Product Change Notice (PCN)

PCN Number: PCN-0451106R-01

Product(s) Affected: PJ-009AH

Reason(s) for Change: Tooling and Material Change

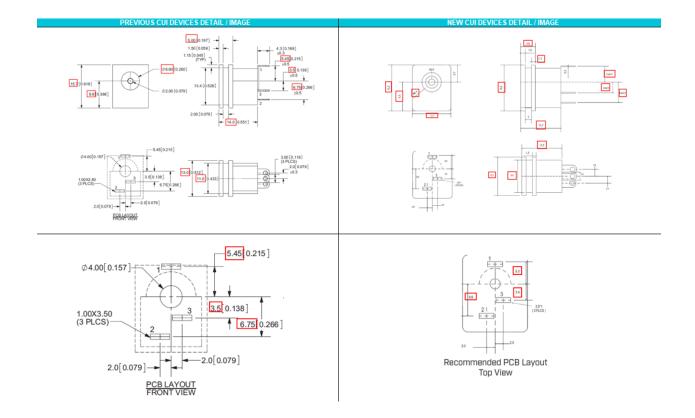
Description of Change: Slight Dimensional difference. Terminal Material Change See image

MATERIAL	PLATING
center pin	copper	nickel
terminal 1	brass	silver
terminal 2	copper alloy	silver
terminal 3	brass	silver
plastic	PBT

NEW COI DEVICES DE	TAIL / IMAGE
DESCRIPTION	MATERIAL	PLATING/COLOR
center pin	brass	nickel
terminal 1	brass	silver
terminal 2	copper alloy	silver
terminal 3	brass	silver
housing	PBT (UL94V-0)	black
